## ADDENDUM NO. 01

### North Stockton Kitchen Renovation at Five Sites

**Project No. 5310-0000-895-75**

March 27, 2026

DESCRIPTION: WELL STATION HANDY SERVING LINE

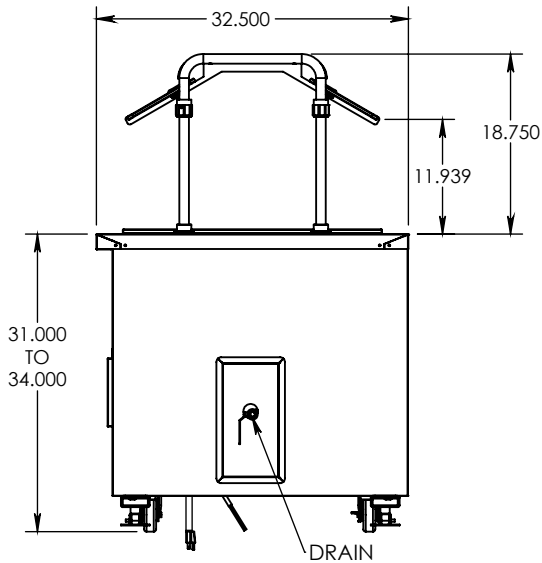
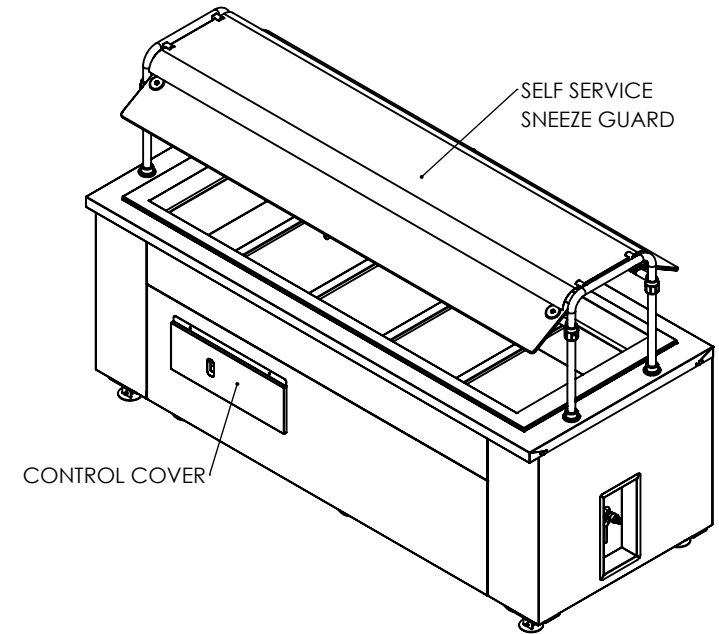
Please provide specifications & details for the new serving lines at these 4 schools. **Only Christa McAuliffe will receive a new Serving line (See 13). All 4 Elementary Schools to receive G.A. Systems model EHCD05 or equivalent. See provided cut sheet.**

FOODSERVICE EQUIPMENT SCHEDULE

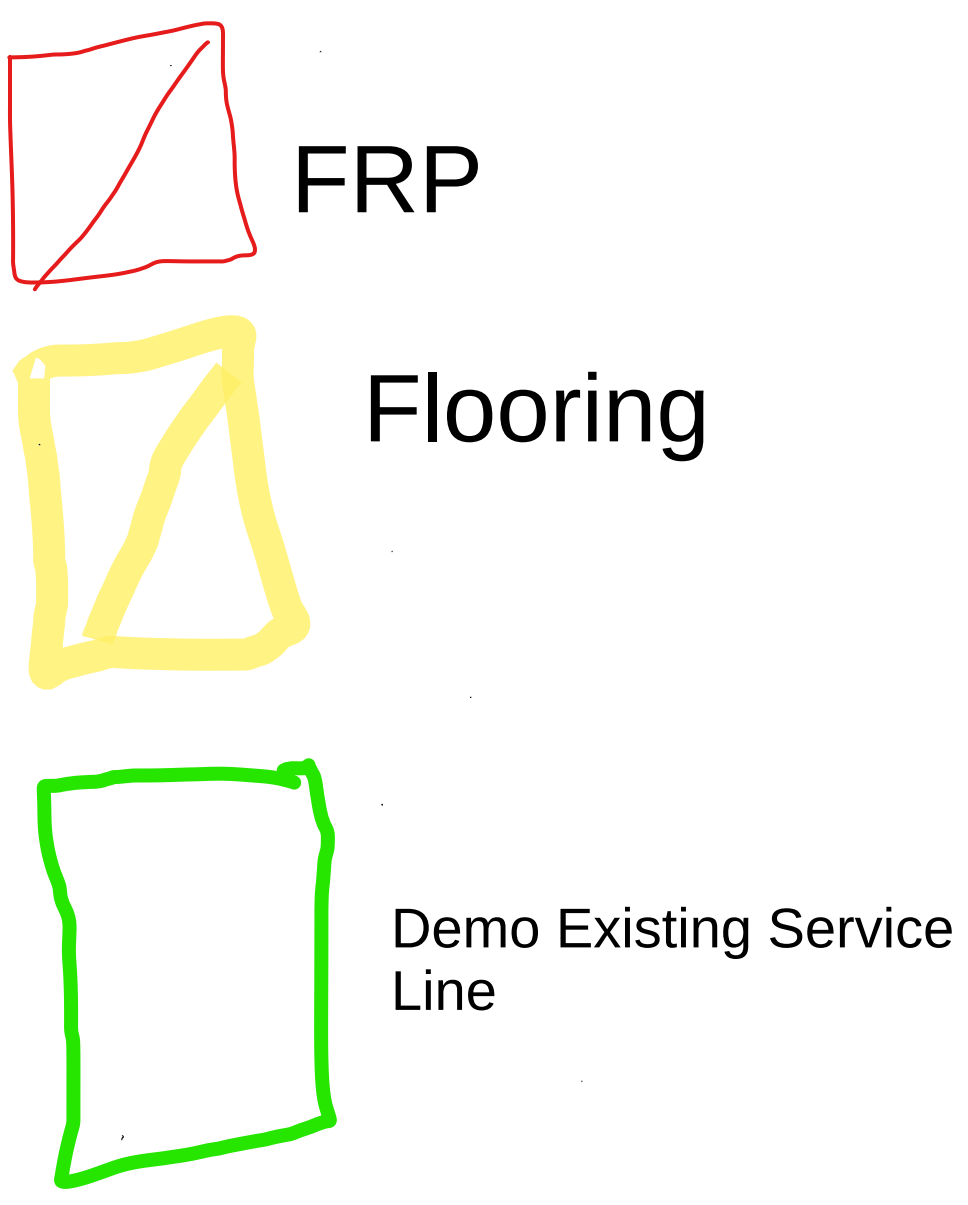
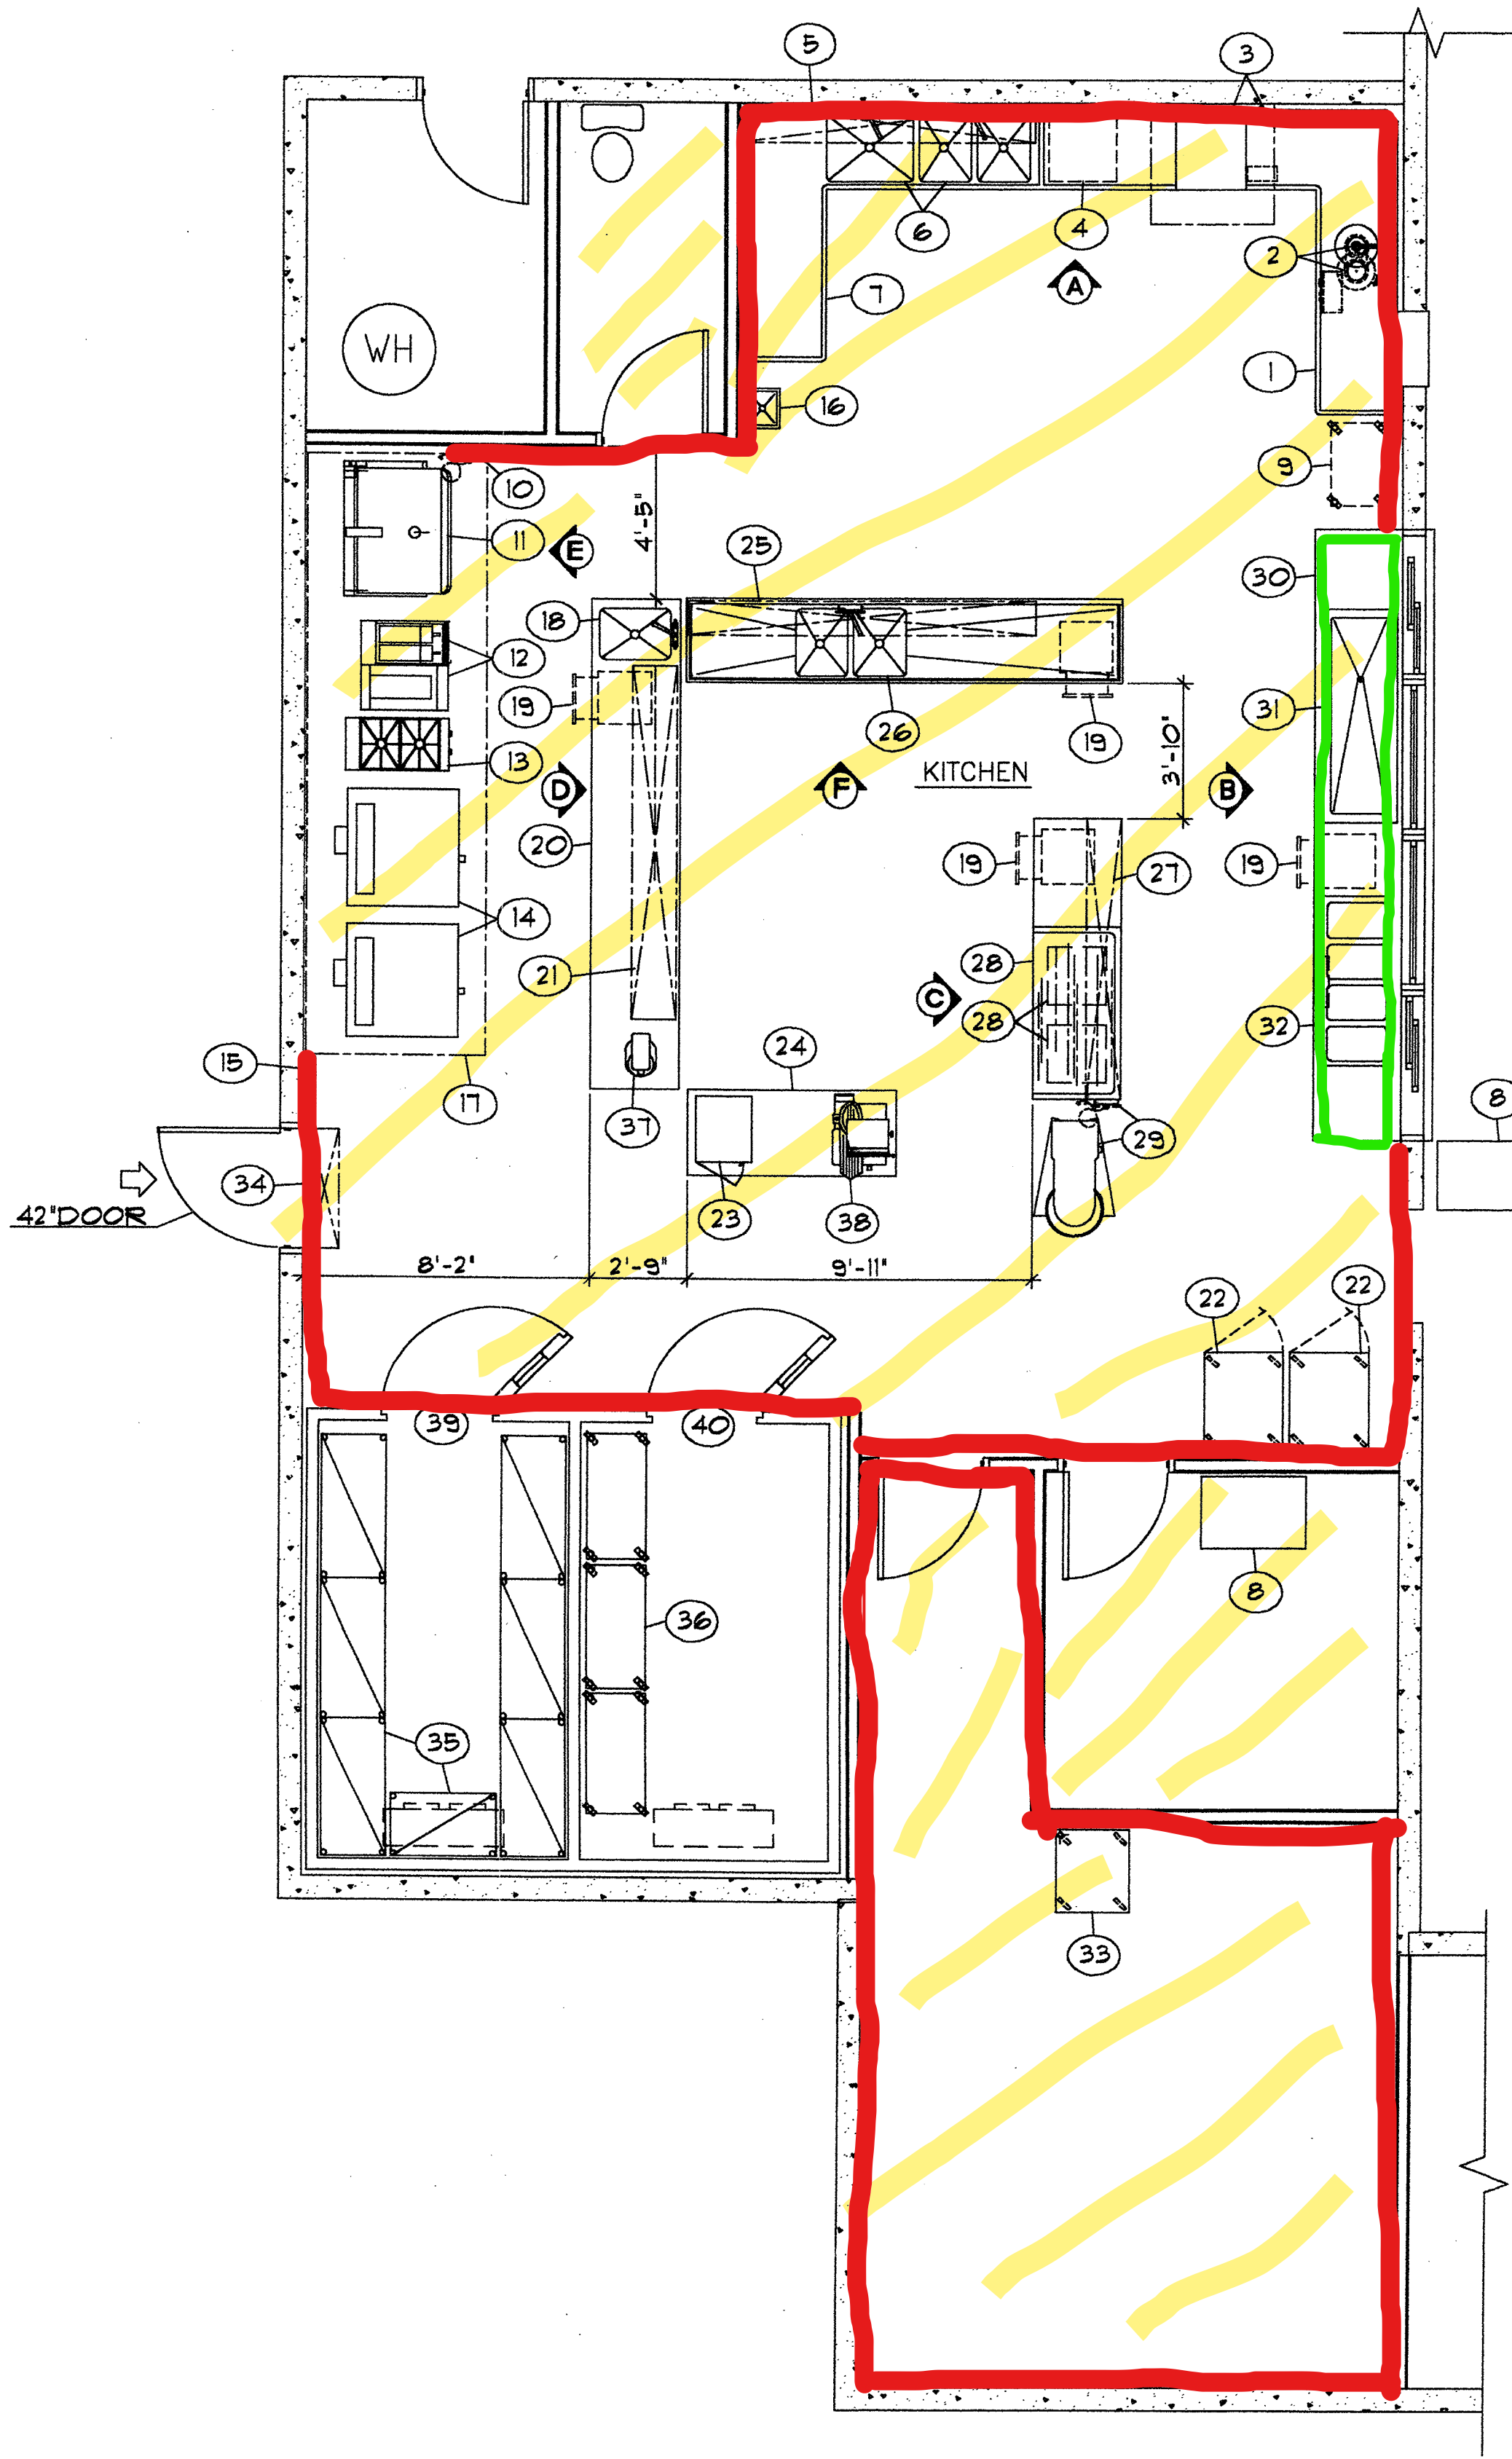
Please provide drawings with connection details & specifications for the new floor sink at this site. **No Floor sink to be installed. Remove this point from Bid and Scope. Equipment requiring floor sink (Tilt Skillet and (4) Convection ovens) to be revised to “Vulcan 30 or 40-gallon VG Series, which must include a drain spout and auto-tilt, or an equivalent model “ and (4) American Range M-2.**

13. Demo Existing Service Counter. Preserve SS surface covering wall. Re secure existing utilities as needed. Replace Service line with (2) G.A. Systems HCD05 (or equivalent) separated by a 32”w x 30”d x 34”h SS table. Table to be topped with a Hatco GR2SDS-24 (or equivalent).

## Flooring

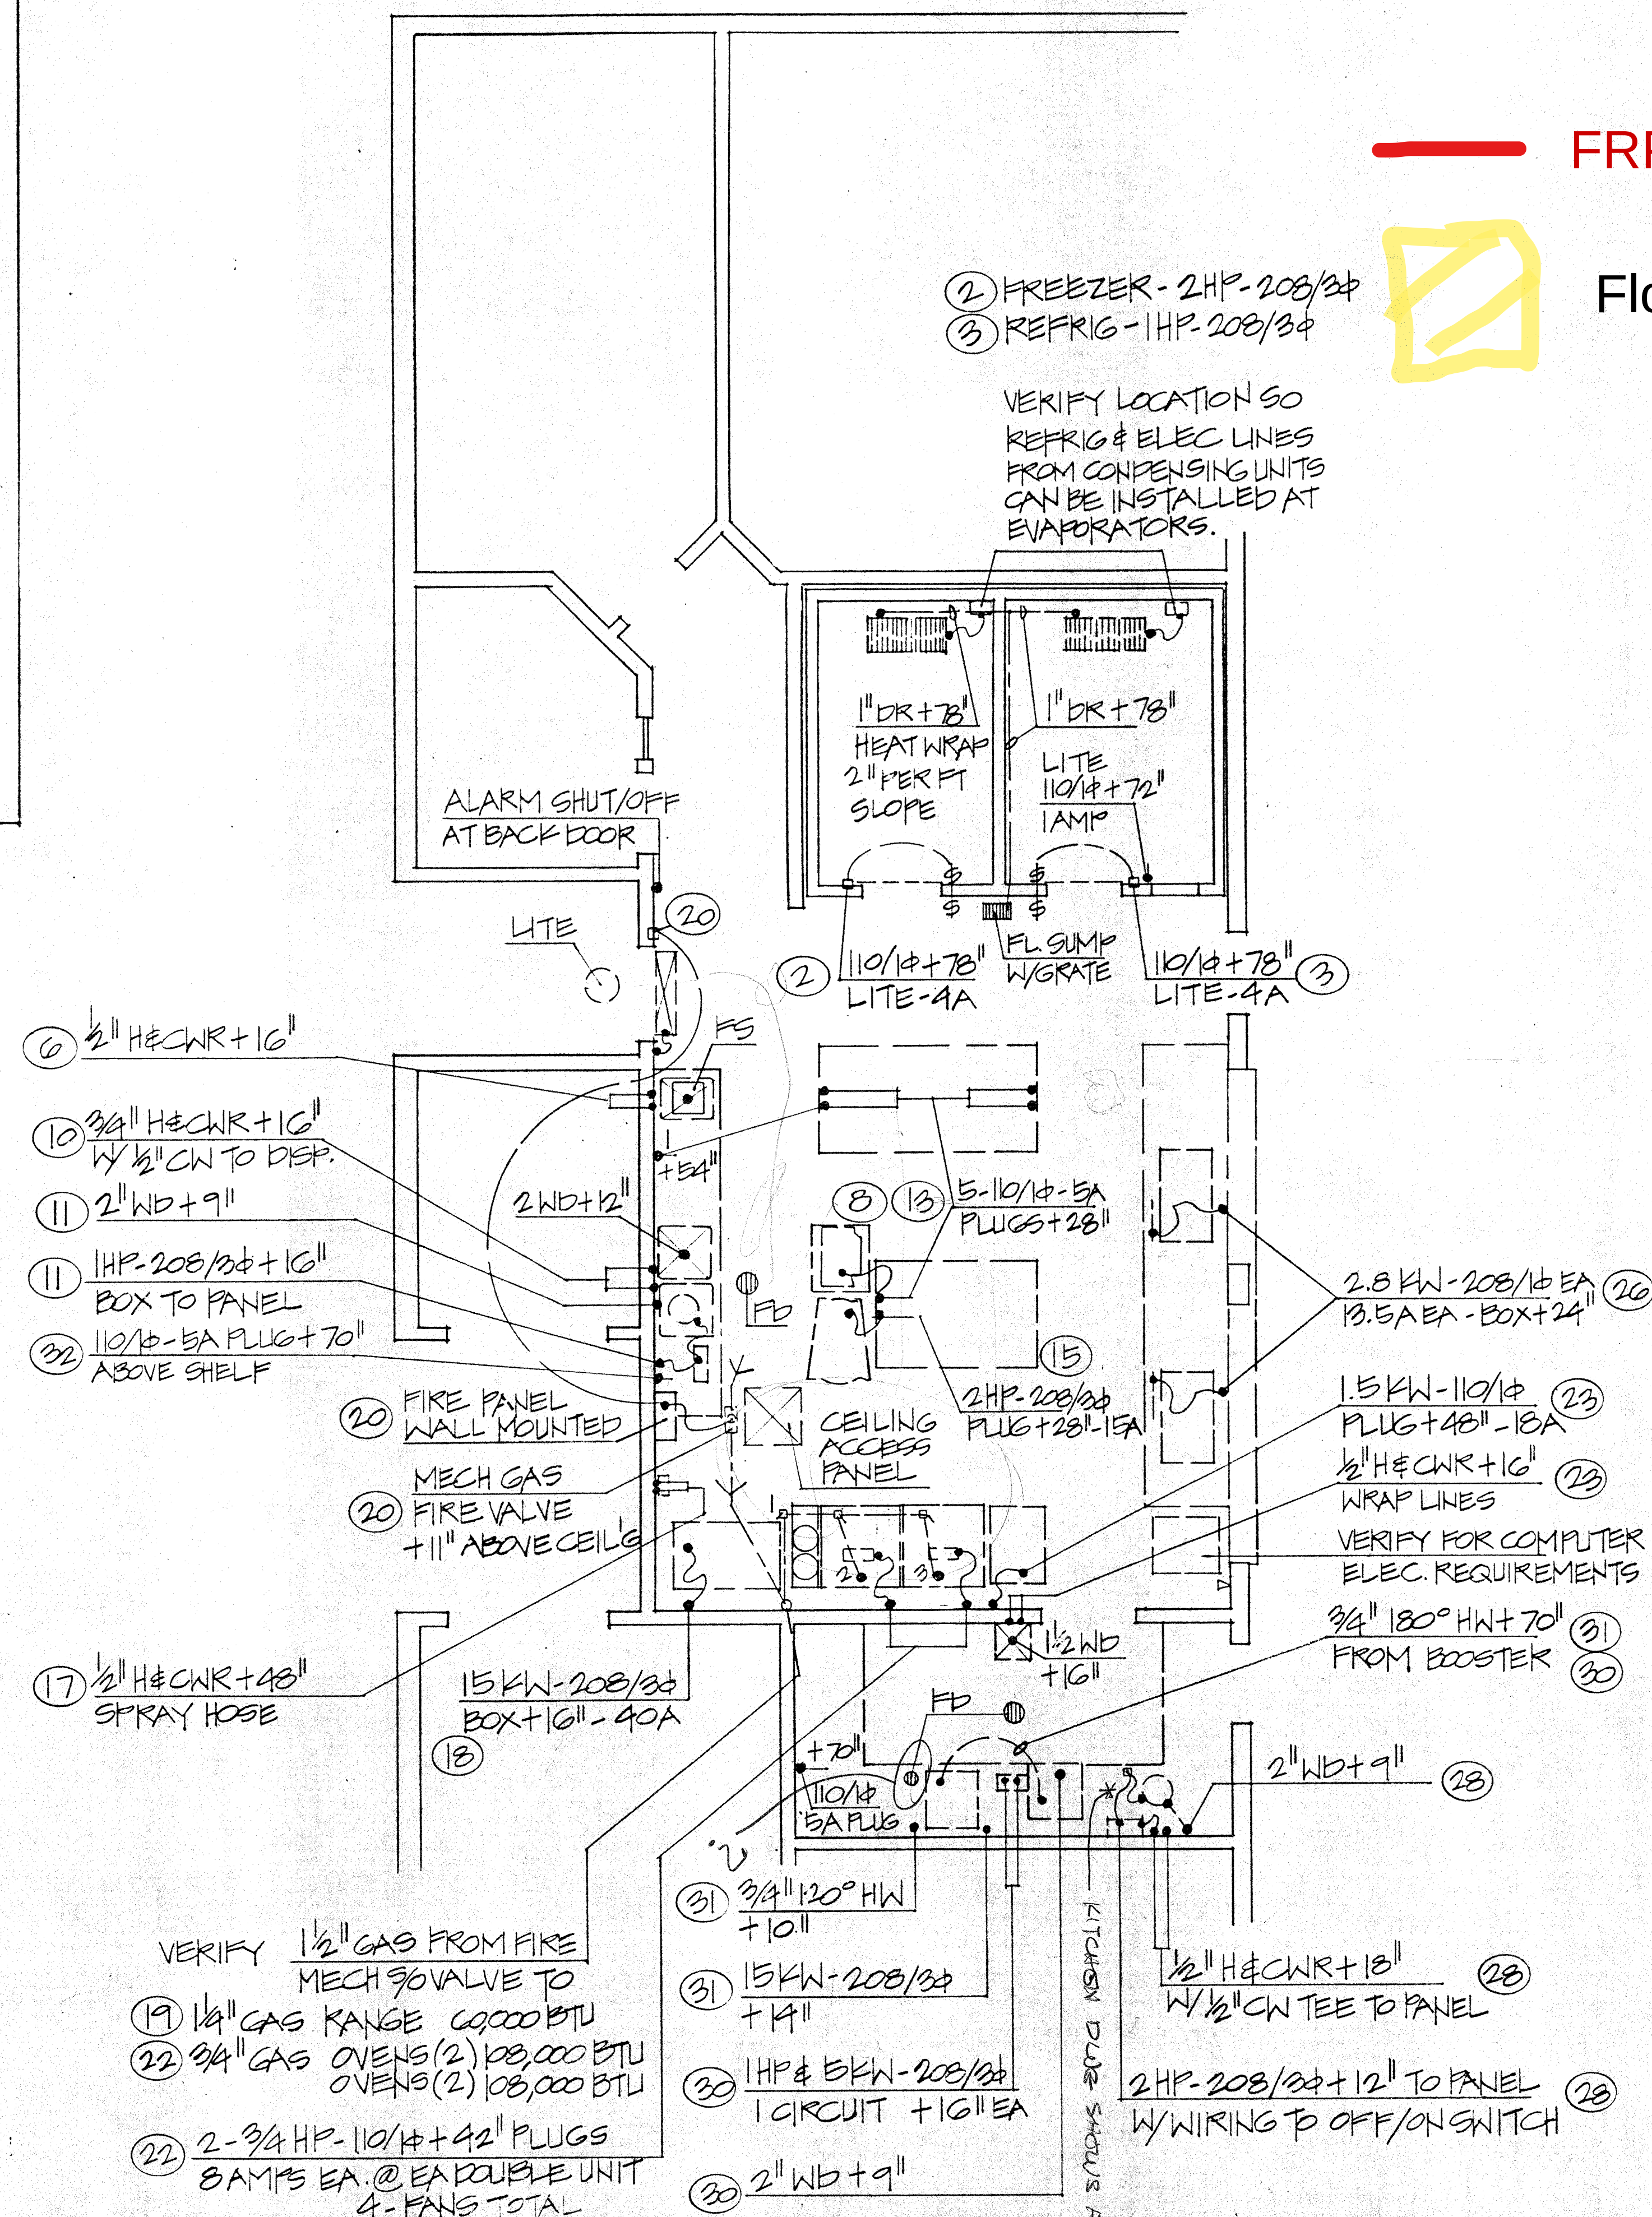
6. "Flooring replacement is specifically called out as to replace in the "Kitchen", however the flooring extends into the offices, storage and dish wash area. We want to confirm that all of the rooms are considered part of the Kitchen." **See attached maps.**

9. Please clarify the amount of FRP that is in need of replace/repair/extend at each site. **See attached maps.**
